35/36-04A 4817 Dorset Avenue  
Somerset Historic District

SUBJECT: Historic Area Work Permit # 332734

**HISTORIC PRESERVATION COMMISSION STAFF REPORT**

**PROPOSAL:** Alterations to approved HAWP for new garage

GARAGE ELEVATIONS

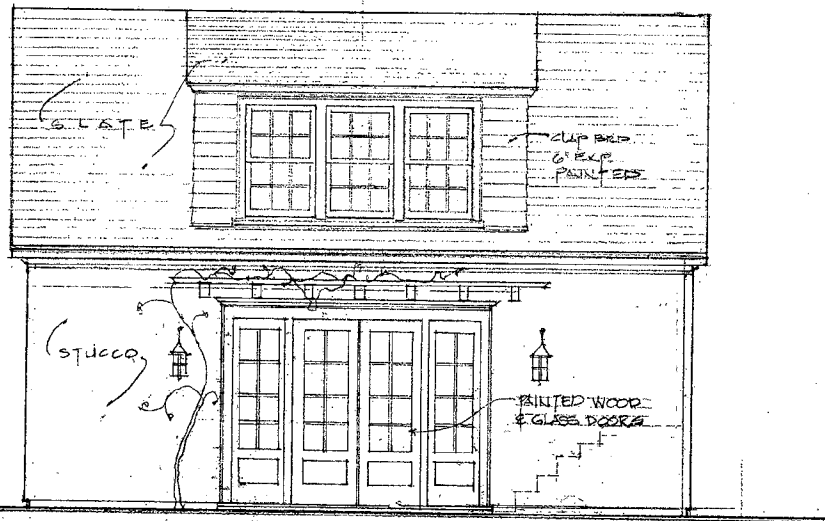
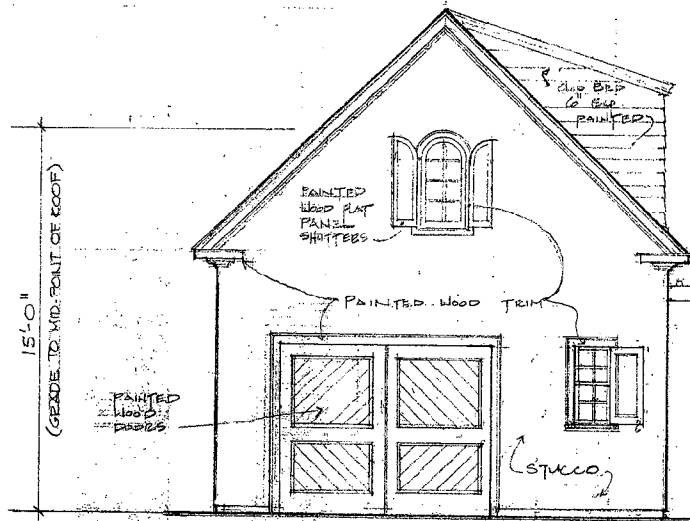
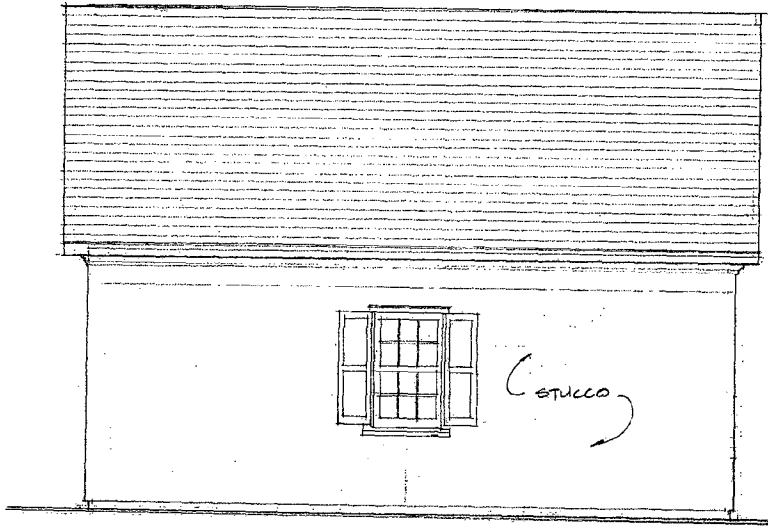
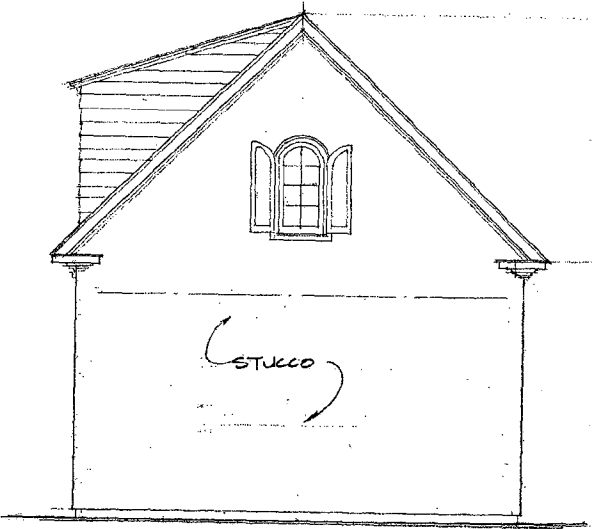
The dimensions of the garage have not changed. The material change proposed for the garage is that it is to be clad in stucco not clapboard. Additionally, they are proposing a new dormer on the east side of the building as well as some fenestration changes (see Circles 10 - 13 ).

Exterior Walls: ~~New painted wood clapboard, 5" exposure.~~ STUCCO

SITE PLAN

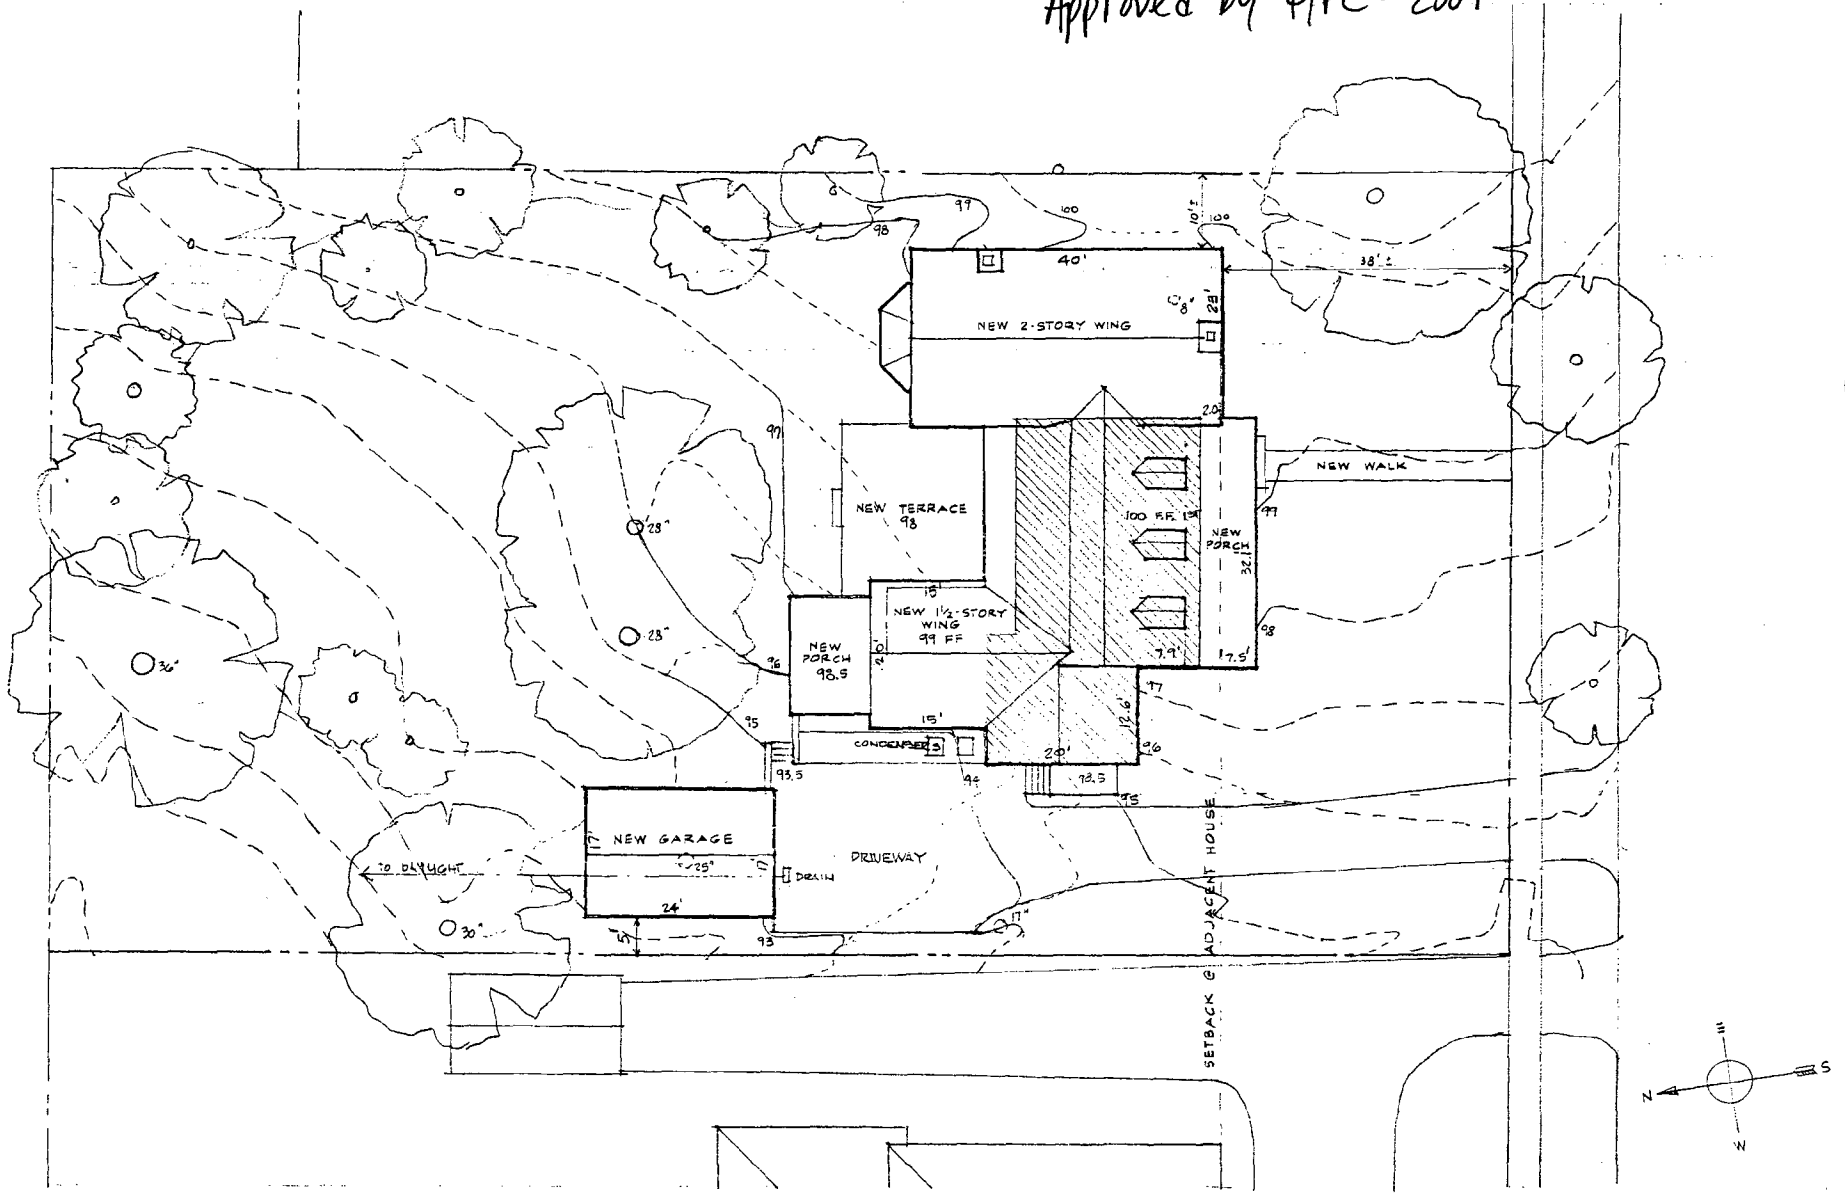
The applicants are proposing a revision to the garage location moving it five additional feet in from the property line, from five feet to ten feet to meet the setback requirements (see 2001 approved and 2004 proposed Site Plans in Circles 9 + 18).
